FINDINGS OF FACT FLORENCE PLANNING COMMISSION Exhibit "A"

Application: PC 22 04 SIR2 01

Proposal: Application for a Phase II Site Investigation Report (SIR) related to slope stability

Location: 56 Shoreline Dr., Lot 37 Shelter Cove Subdivision, Phase 2

| Α | Findings of Fact |
|-----------|--|
| В | 56 Shoreline Dr. Site Plan |

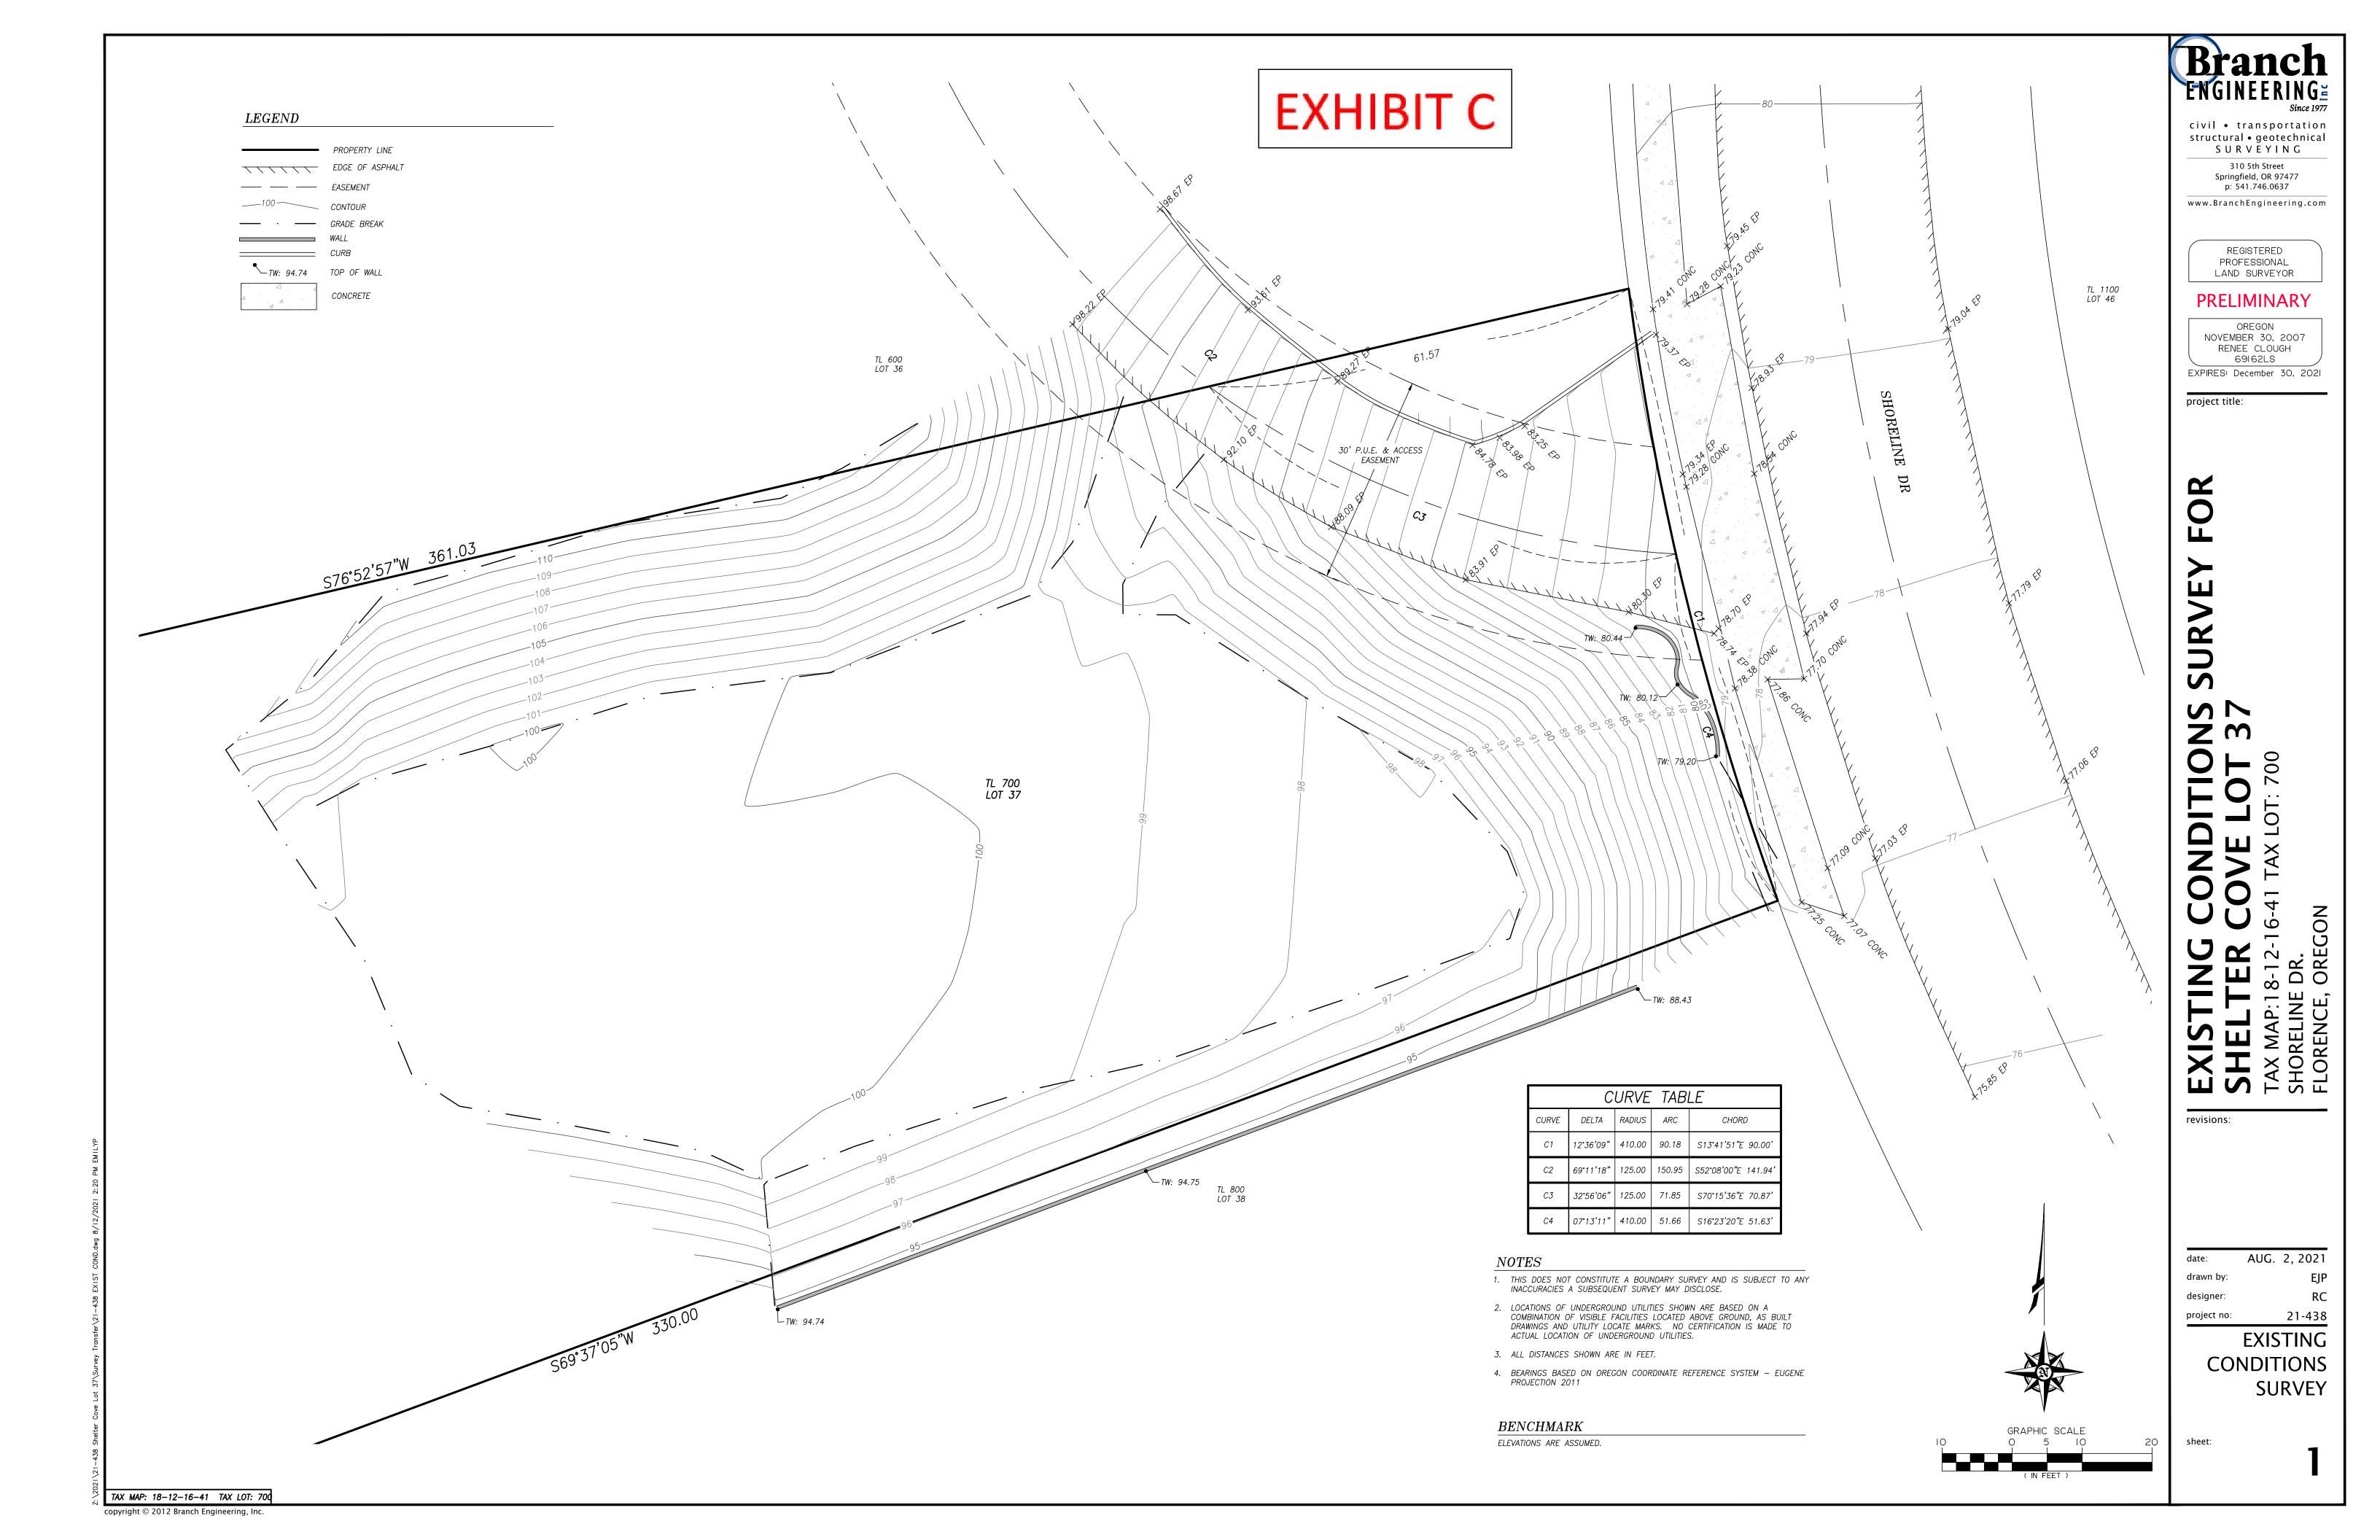
presence of soils and their locations a Phase I Site Investigation Report (SIR) was required. The application did include a site plan illustrating a 50' setback line. The label states it is the top of bank. However, it does not follow the contour for top of bank but rather is a somewhat straight line aligned on the top most north-south oriented contour line. It is there where the 50' is met but where the contours wrap eastward on the south side of the lot the home is setback at most 20' from top of bank. The 50' top of bank setback from a cutbank is not met. Their home foundation is proposed to be engineered.

The proposed site plan does not include construction activity or disturbance within the 50' buffer zone as measured from mean high tide. Buffer zone length criterion is met. Vegetation removal to place the home, utilities and vehicular access is proposed. The home is oriented, sized and/or designed to encroach onto the 50' top of bank building setback on the north and south sides of the lot which creates a situation whereby vegetation is proposed to be removed that would otherwise be retained. Vegetation retention criterion is not met.
